ADDENDUM NO. 1

Smathers Beach Restrooms – West ITB 19-018

Smathers Beach Bathroom West

Response to RFI #1.

TITLE: SITE PLAN

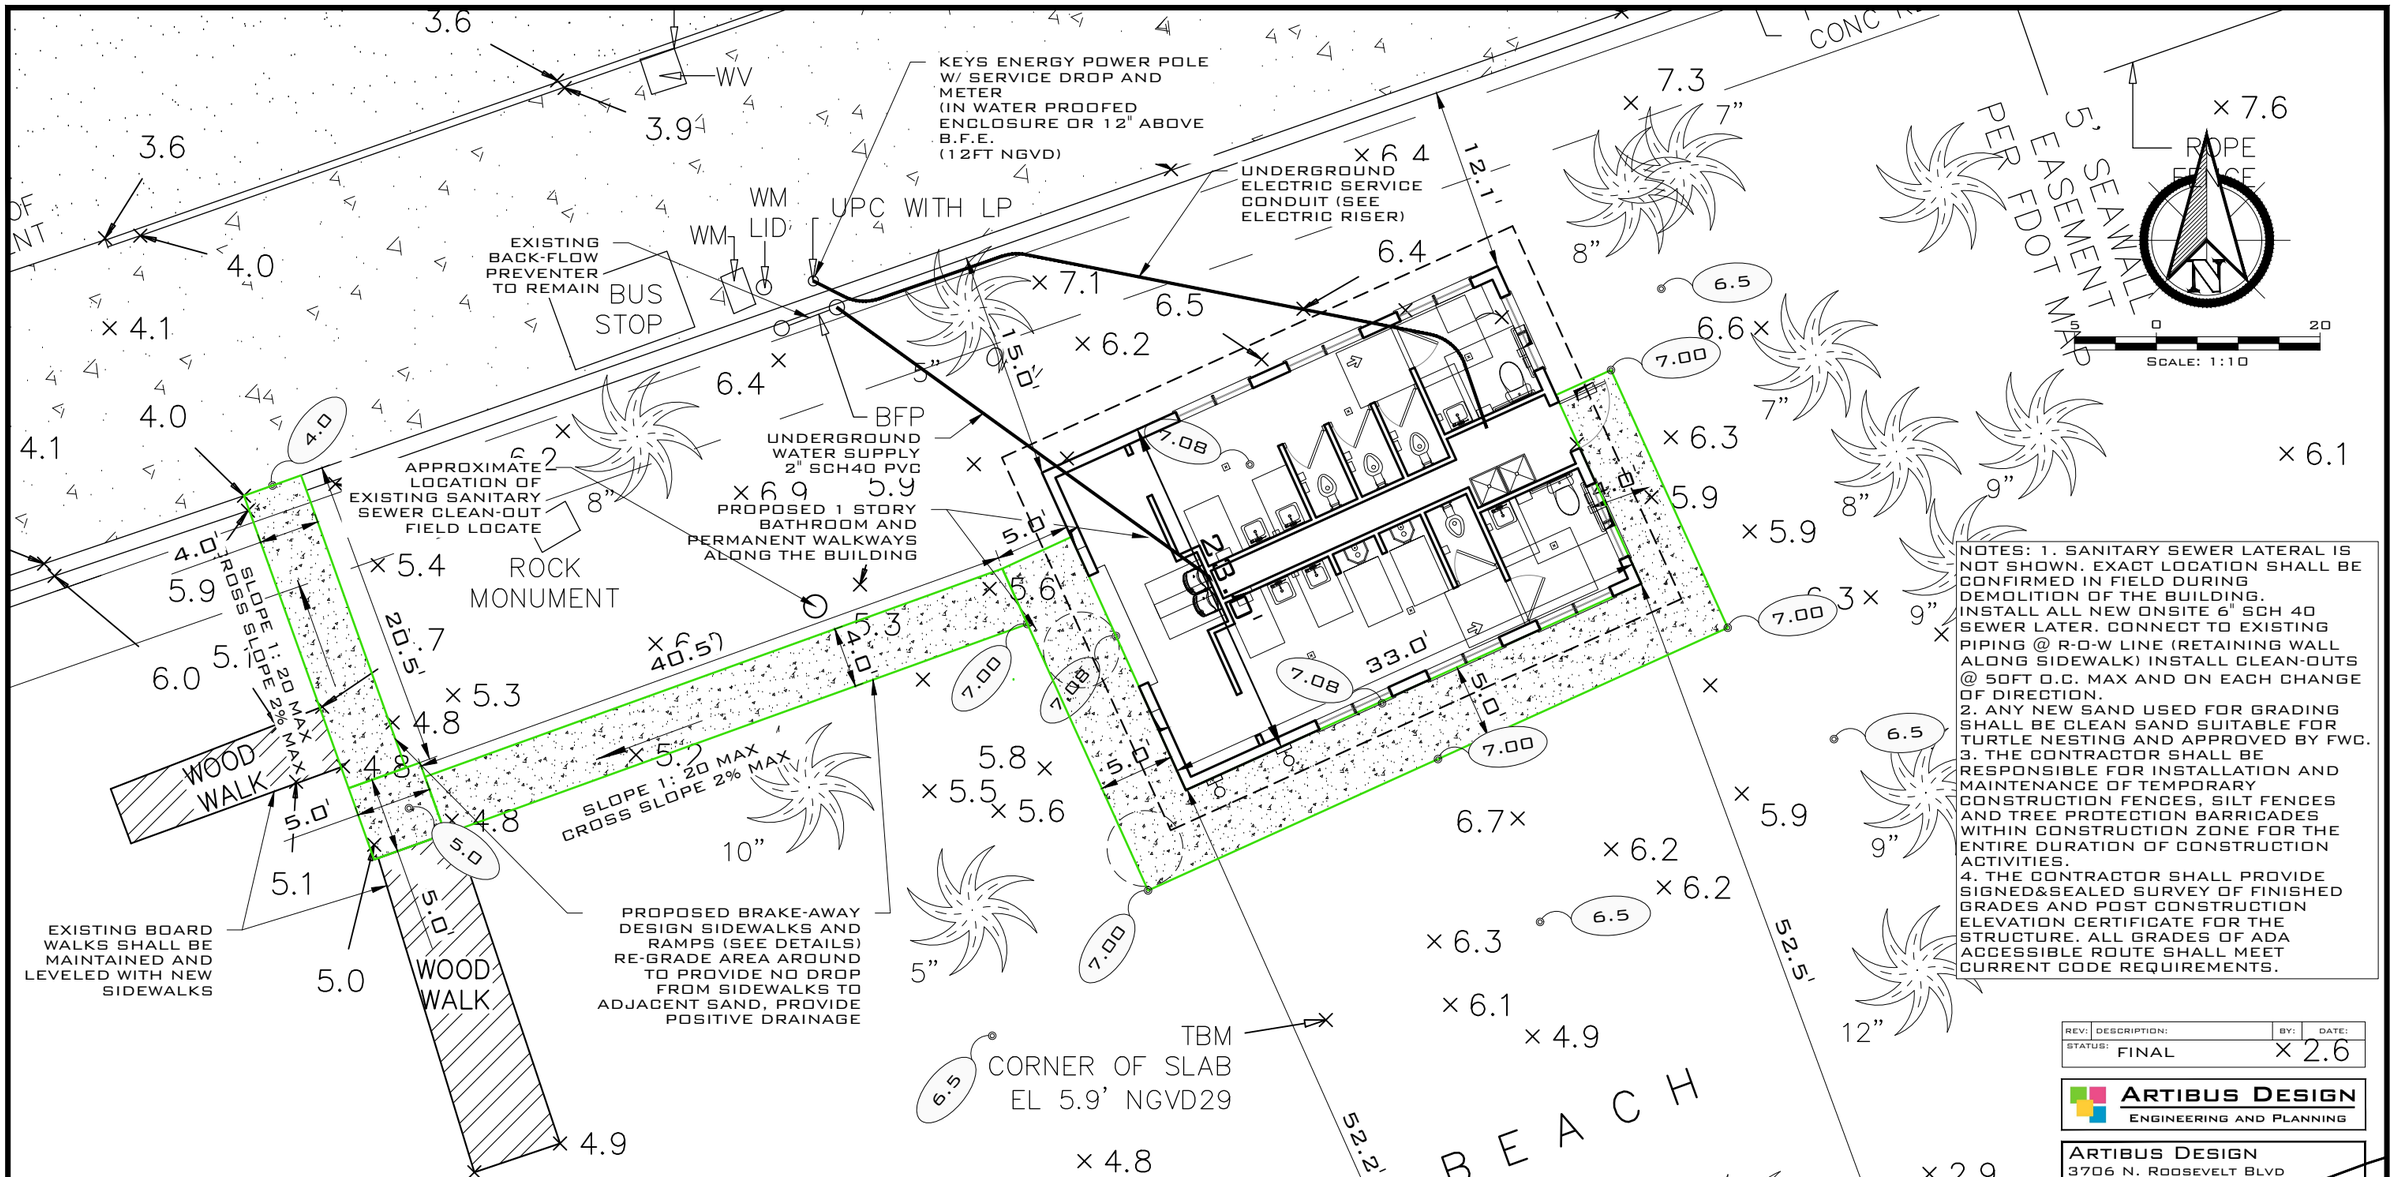
1. Sheet C-102 shows 52.2' from the Mean High Water Line to the Southwest Corner of the structure. The 11" thick 5'-0" wide Permanent Concrete Sidewalk is part of the Bathroom Foundation. Is the south sidewalk required to be outside of the Coastal Construction Line? If not, what about the 2'-0" Roof Overhang?

2. Sheet C-102 Note #2 reads "Any New Sand used for Grading shall be Clean Sand Suitable for Turtle Nesting and Approved by FWC." Please specify the type of sand required.

7. Sheet S-101 shows a 4'-0" wide Concrete Sidewalk along the East and South Sides. The 5'-0" wide Sidewalk along the West runs to the Northwest Corner. Sheet C-102 shows a 5'-0" wide Sidewalk along the South. Additionally, the West Sidewalk terminates at the Break-Away Sidewalk (not at the Northwest Corner). Please clarify.

Response: According to our coordination with CCCL permitting office the building does not need a CCCL permit as designed. The installation of sidewalks and other minor structures with that line will require a field permit and is being coordinated by the design team.

Response: The City shall provide sand specifications from previous beach re-nourishment projects. Sand shall be mined beach sand (not manufactured).

Response: South and west sidewalks adjacent to the building shall be 5.0' and east sidewalk leading to maintenance access door shall be 4.0' wide. Site plan layout C-102 shall be used for site layout.

TITLE: PROPOSED FLOOR PLAN

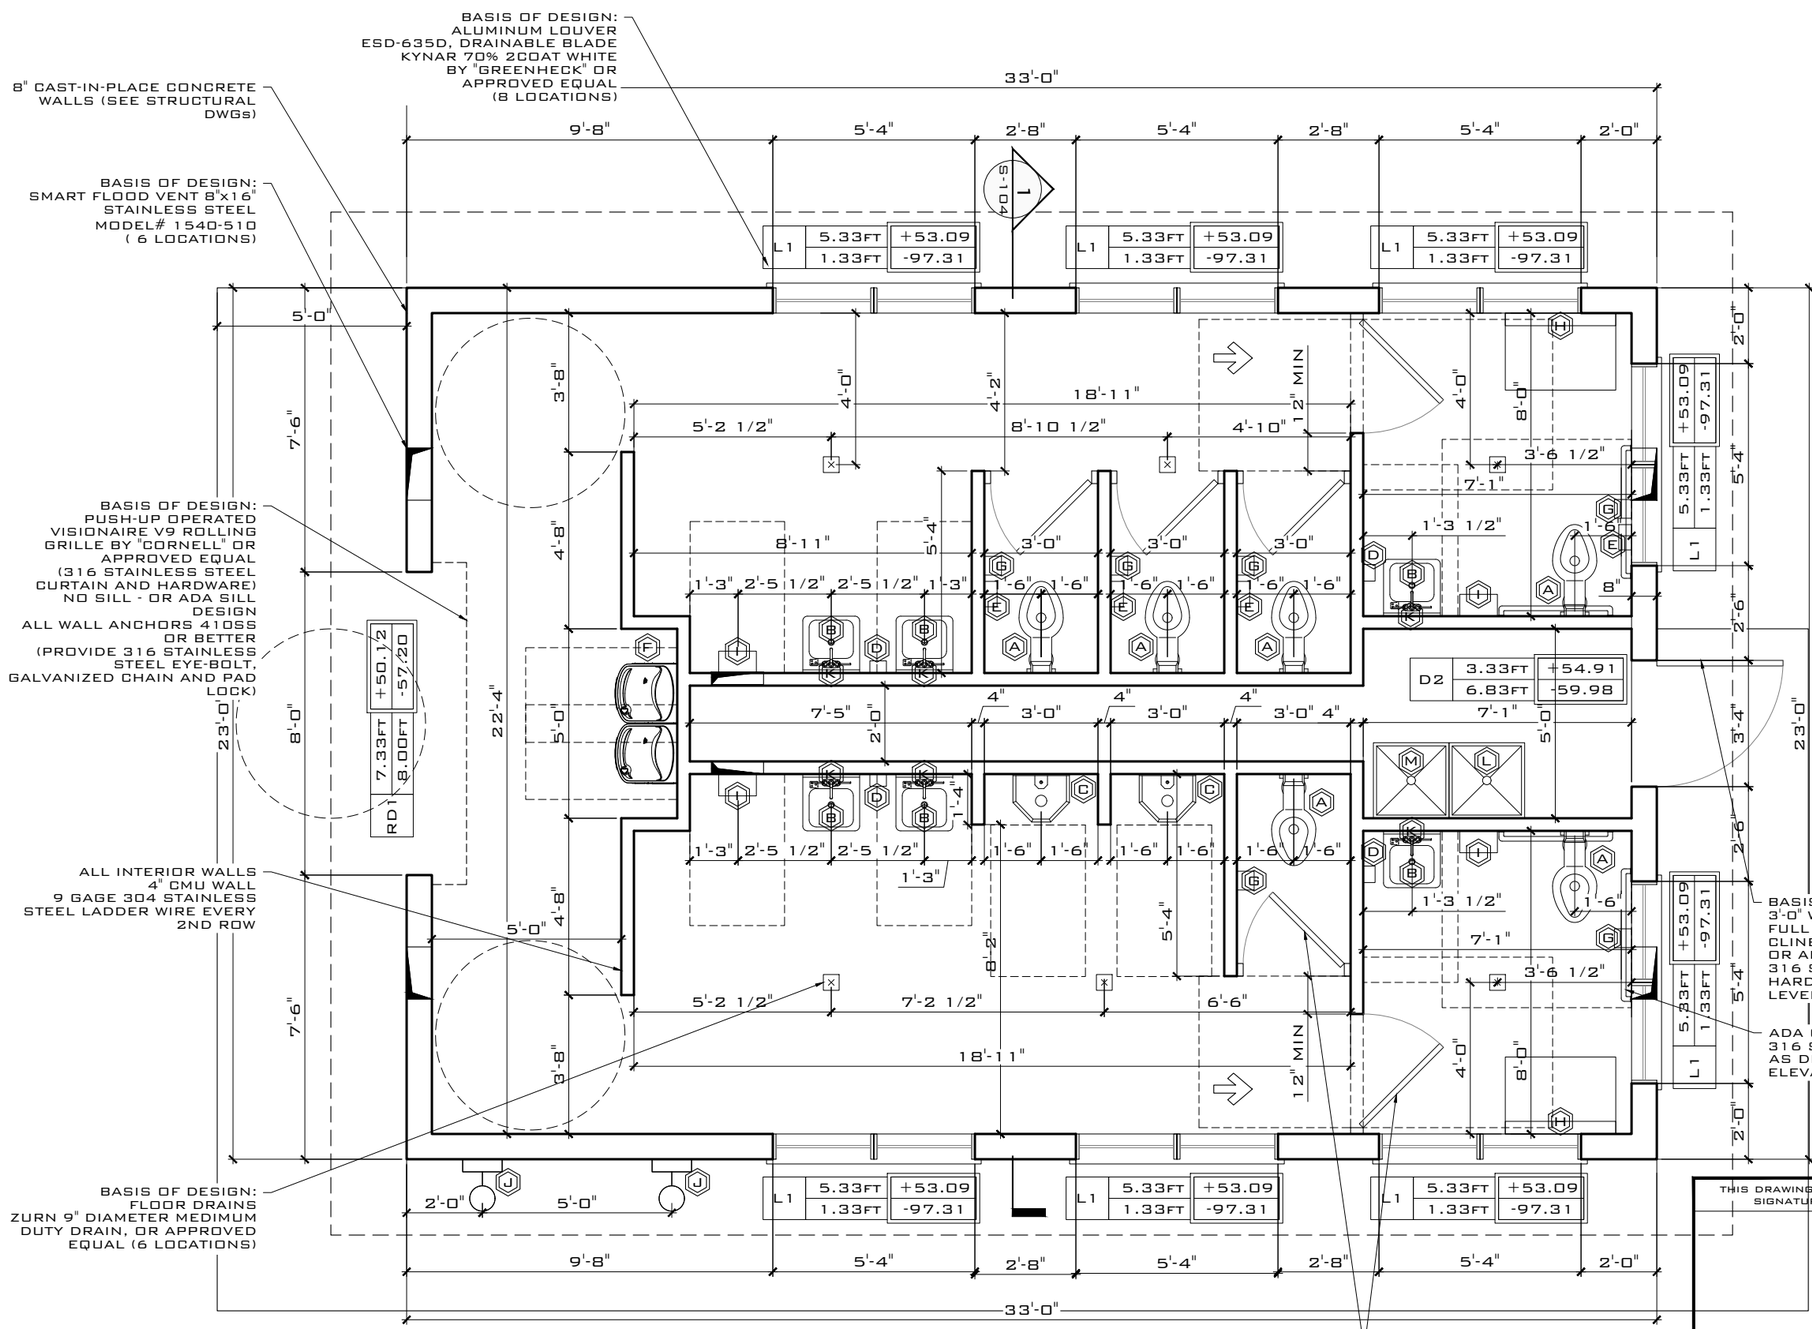
3. Sheet A-101 includes "Add Alternate Bid Items" however the Proposal Form does NOT include any alternates. Please clarify.

Response: City to provide an updated form with Add Alternate Bid Items.

TITLE: PROPOSED RIGHT/FRONT
ELEVATIONS

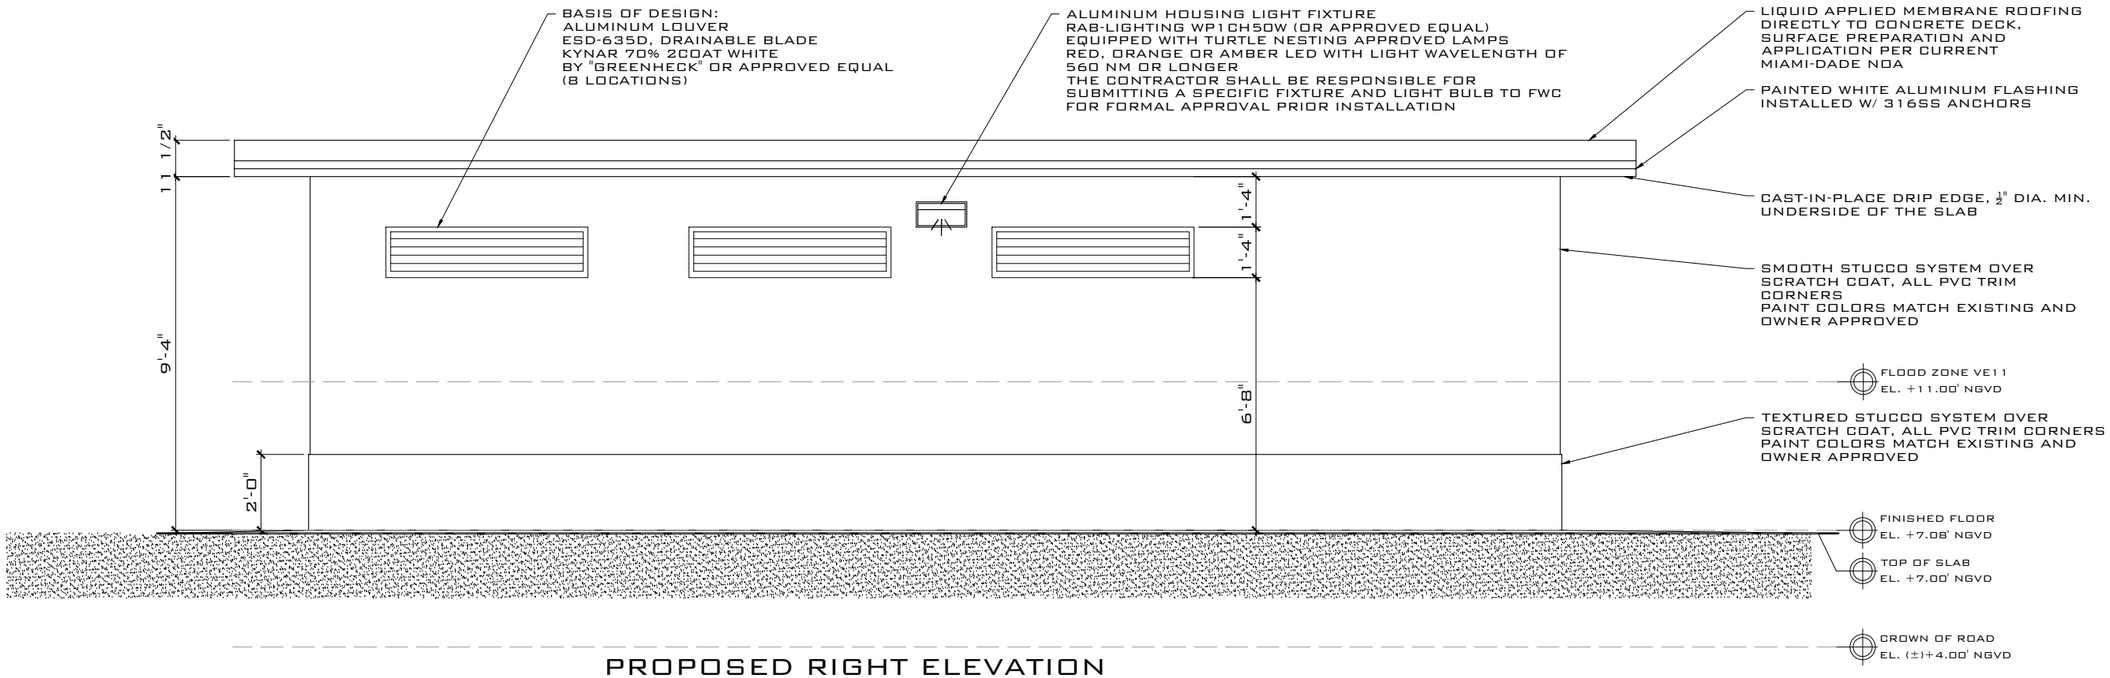
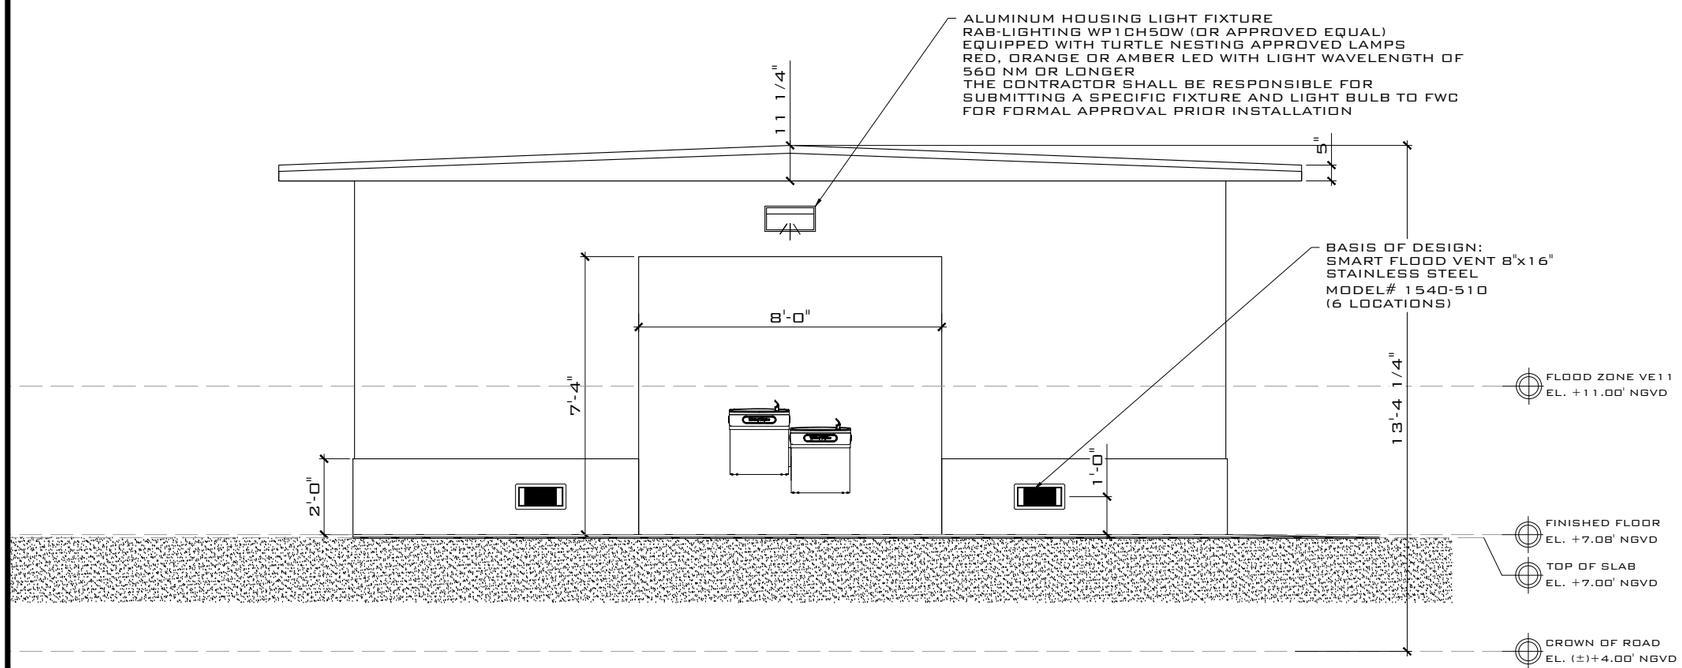
4. Sheet A-102 shows a reveal between the 2'-0" tall Textured Wall and Smooth Stuccoed Exterior Walls. Please indicate how much stucco reveal?

Response: 1/2" reveal.

TITLE: PROPOSED BATHROOM
ELEVATIONS

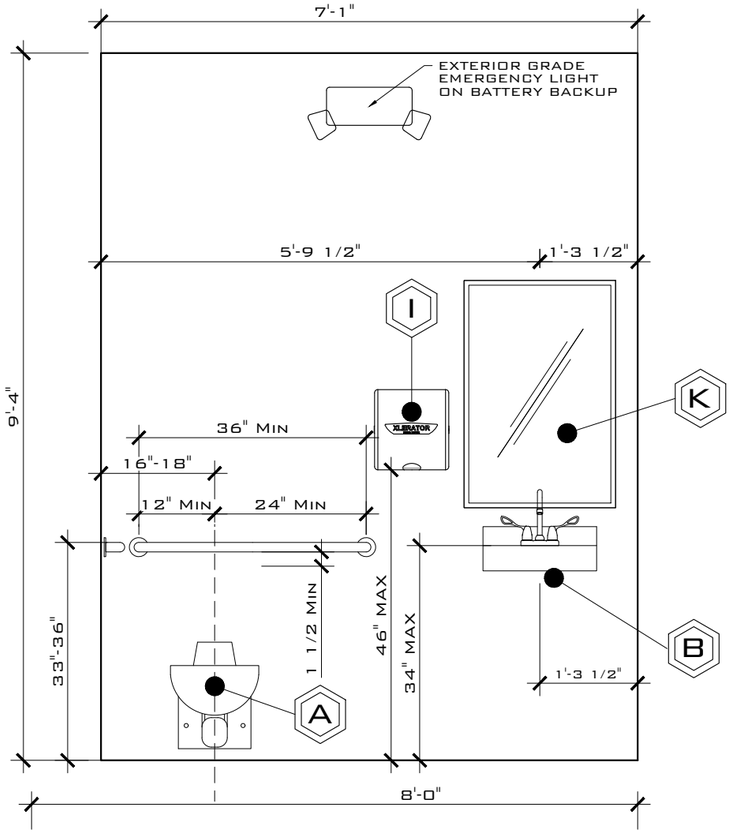
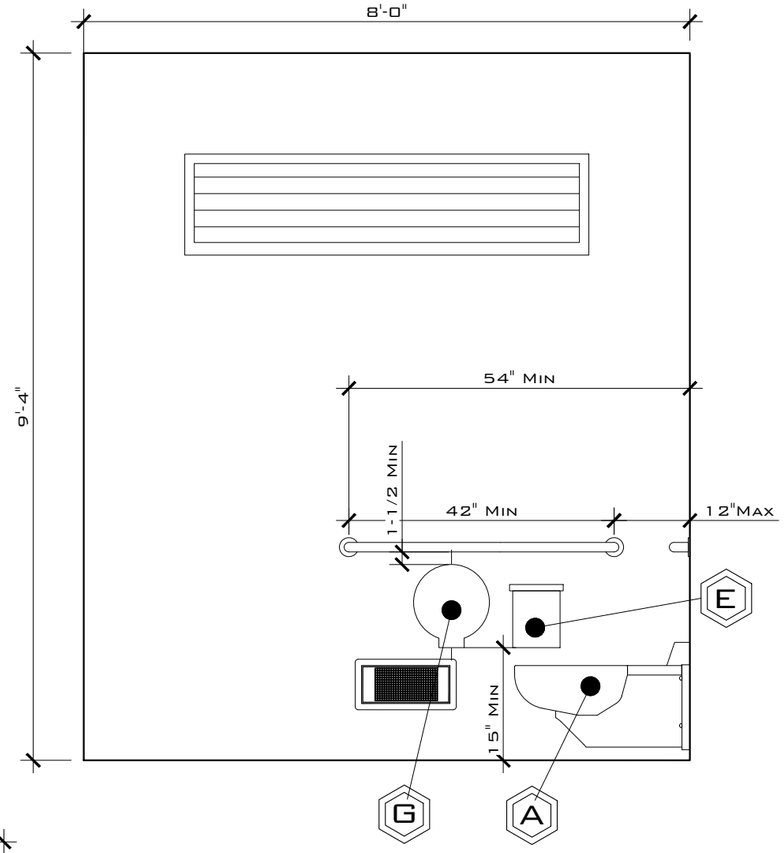
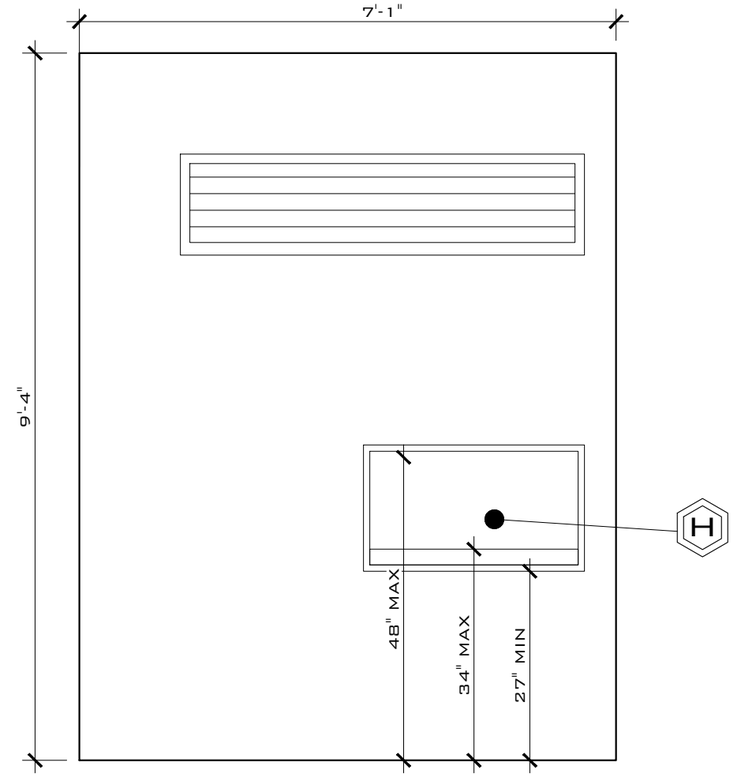
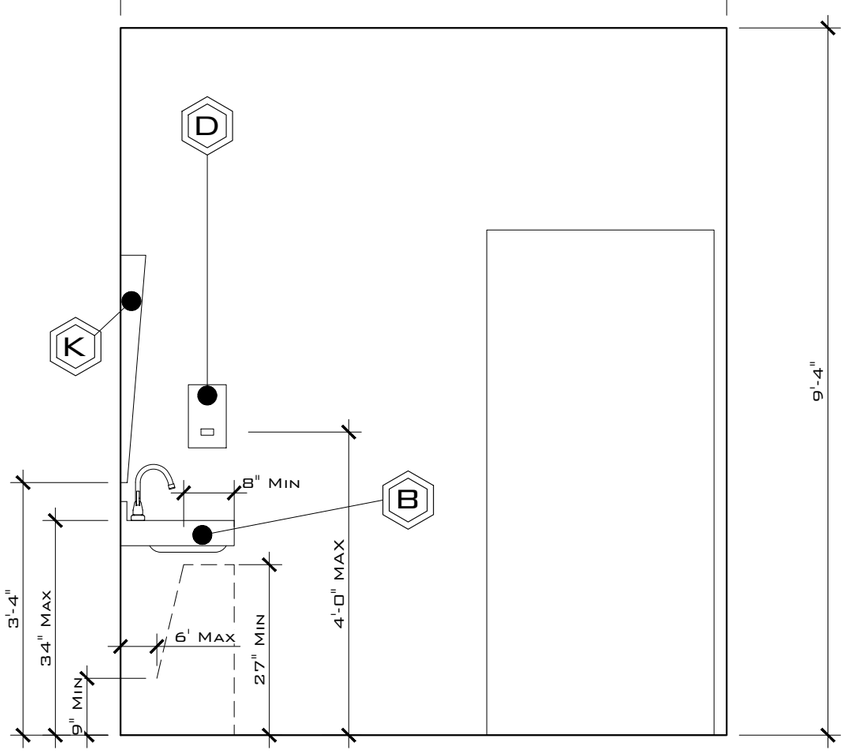
9. Sheet E-101 reads "All Electrcial Components Shall be Located 12" Above Base Flood Elevation" (EL + 12.0 NGVD). However, Sheet A-104 shows the maximum distance above Finished Floor is 46". Finished Floor is +7.08 + 46" = EL +10.91. Please clarify.

Response: Hand dryers shall be considered sacrificial equipment and located as indicated on the plans and per current ADA requirements. All other equipment shall be located 12" above base flood elevation.
